GS #323-024 ARPA INFR. – WASTE CENT. TREATMENT SOUTH MISSISSIPPI CORRECTIONAL INSTITUTION LEAKESVILLE, MISSISSIPPI

ADDENDUM NO. 2 May 23, 2024

The Contract Documents for GS #323-024 ARPA INFR. –WASTE CENT. TREATMENT South Mississippi Correctional Institution Leakesville, Mississippi, are amended as follows:

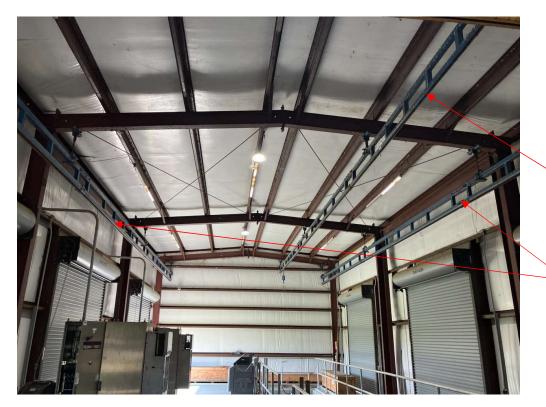
- i. The contractor is required to prepare a SWPPP plan.
- k. The bridge crane and anti-fall beam are only required for the filter and UV buildings. The anti-fall beam and bridge crane are not required to be structurally independent of the building frame. Pictures are attached this document which show what is required from a previous project Burle designed.
